ADMINISTRATIVE AMENDMENT NOTICE

Petitioner #:2008-031

SUBJECT: Administrative Approval for Petition No. 2008-031 Mountain Island Promenade, LLC

MOUNTAIN ISLAND PROMENADE PETITION NO. 2008-031

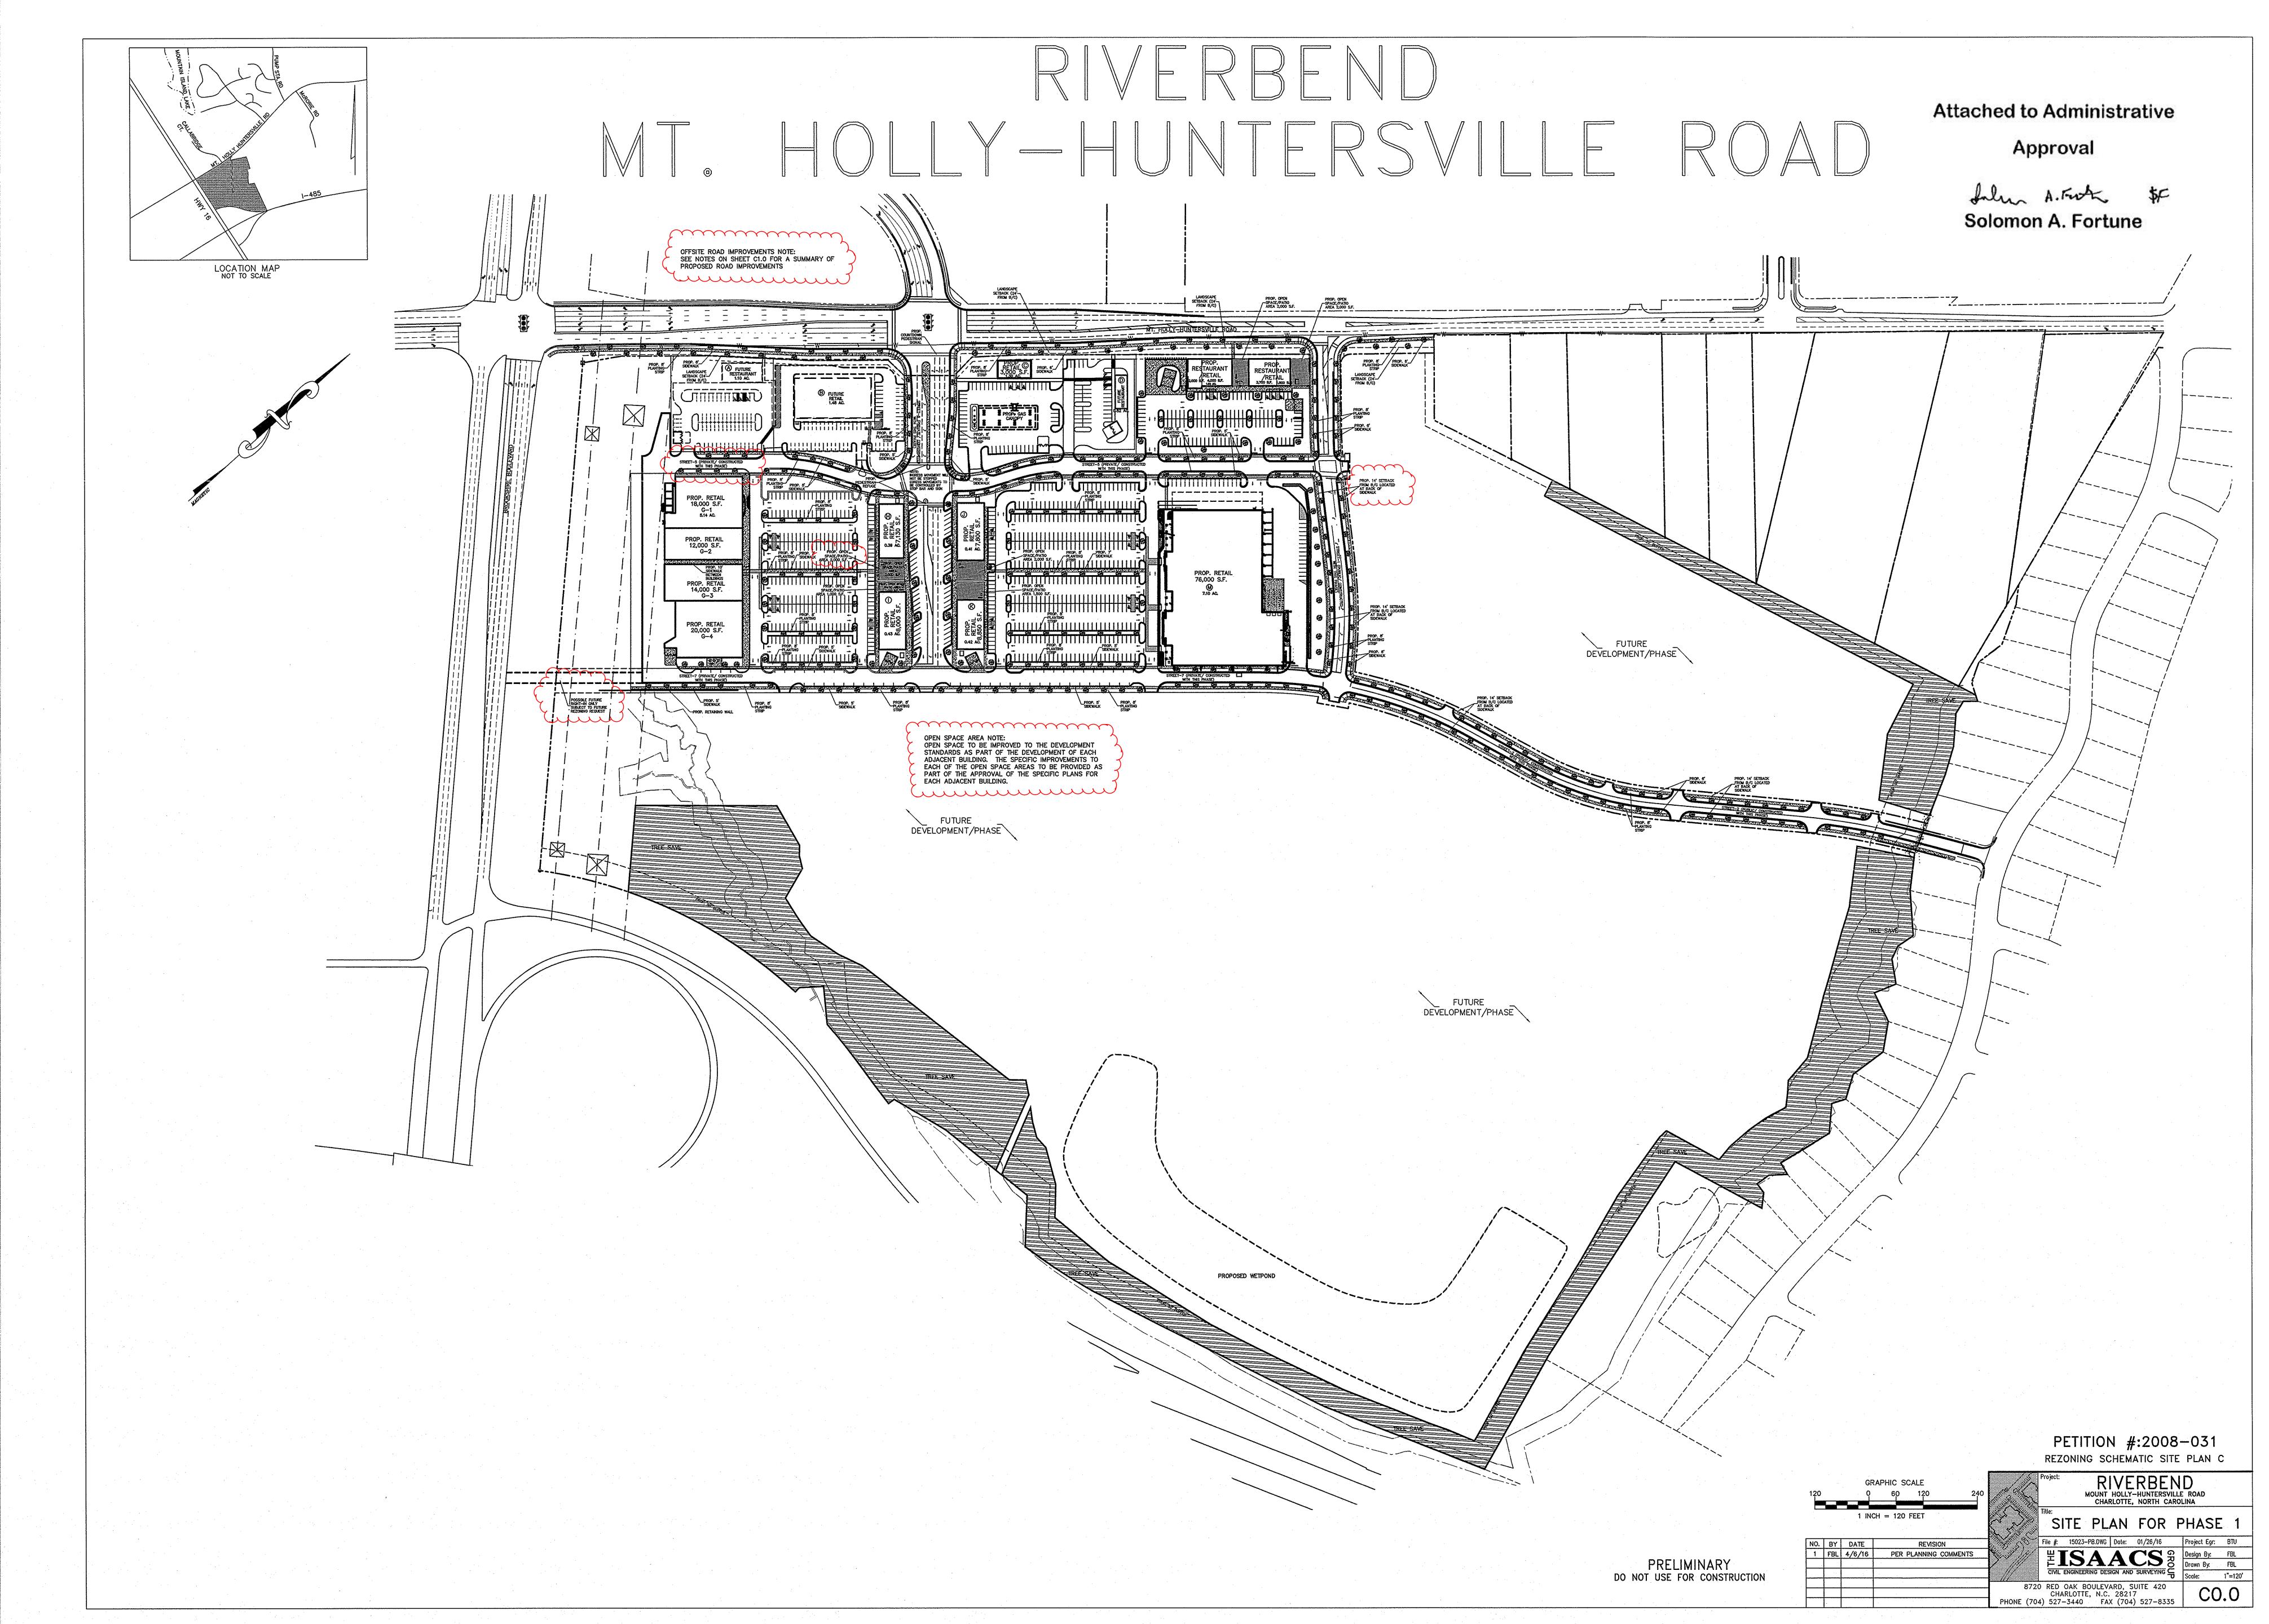
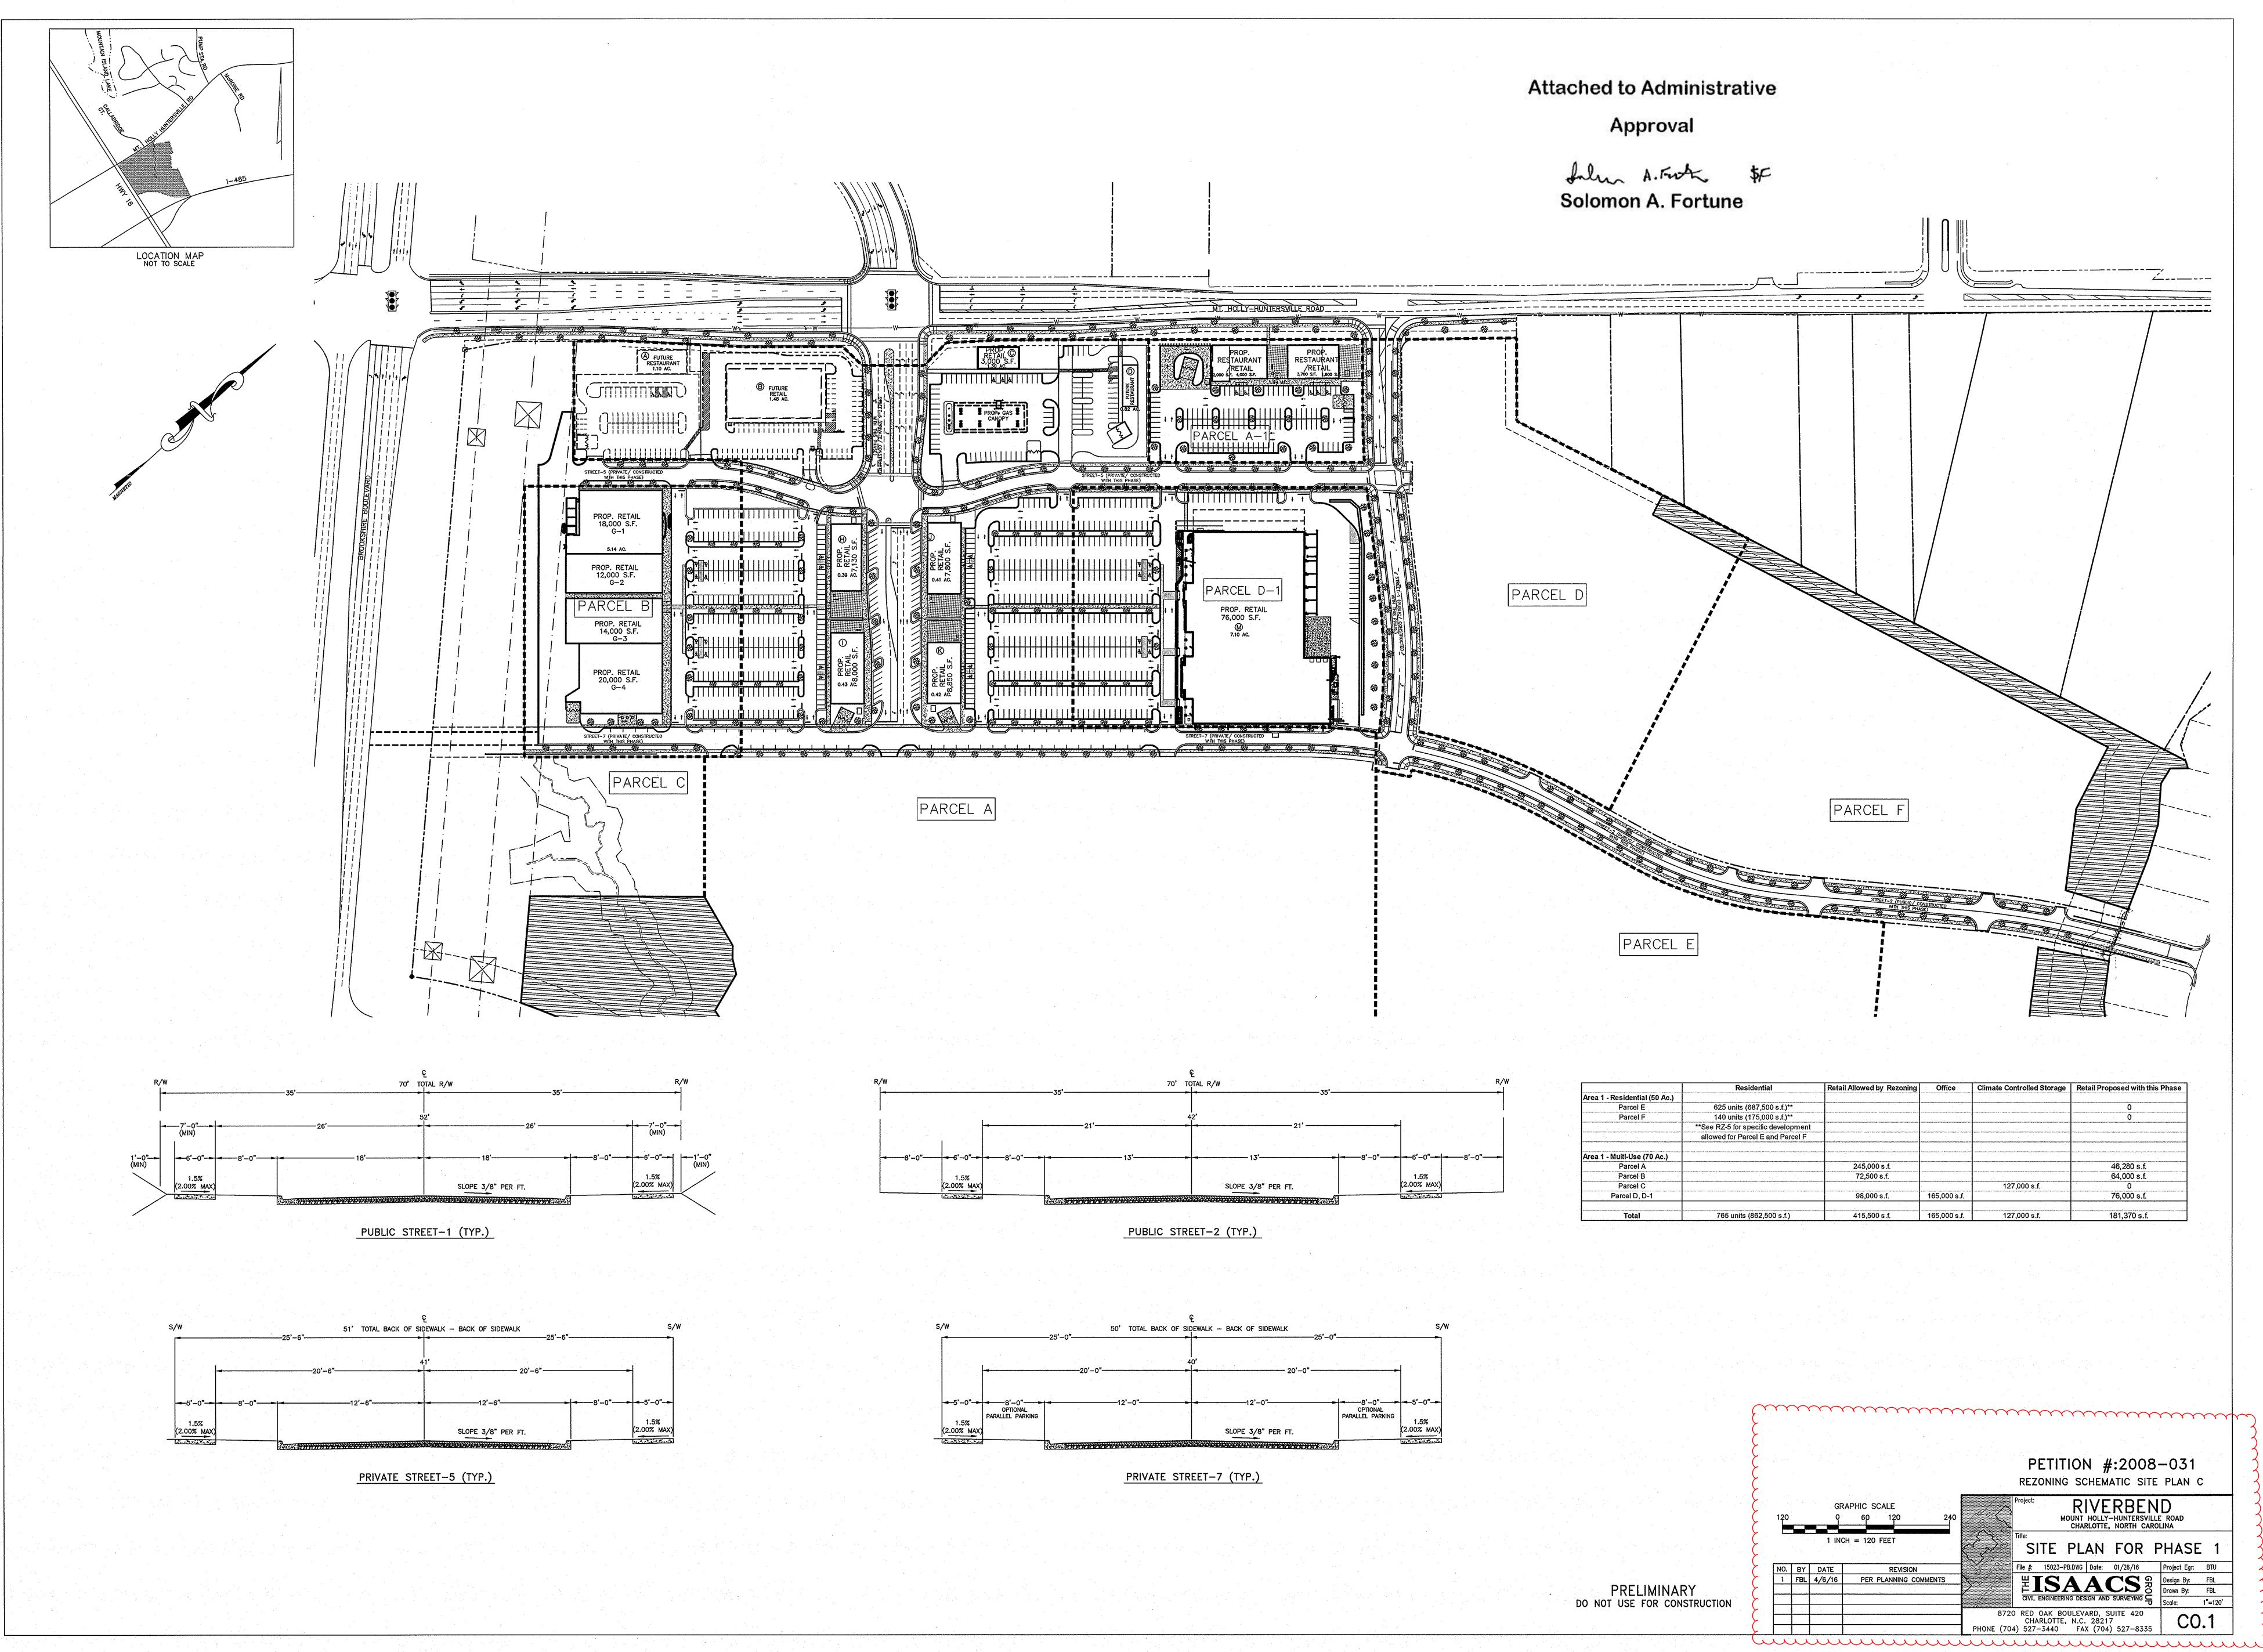
Attached is the revised site plan for the petition above. This request allows the modification of the proposed site plan as listed below. Since these changes do not alter the intent of the development and meets the requirements of the Charlotte Zoning Ordinance Section 6.207 <u>Alterations to Approval</u>, minor changes, I am administratively approving this plan. Please use these plans when evaluating requests for building permits and certificates of occupancy.

- General layout for proposed retail buildings.
- Note modification: Elevation and review will happen prior to commercial building standards review.
- Master site development record
- Open space and green areas are tied to certain buildings being developed.
- Screening wall along proposed internal public street
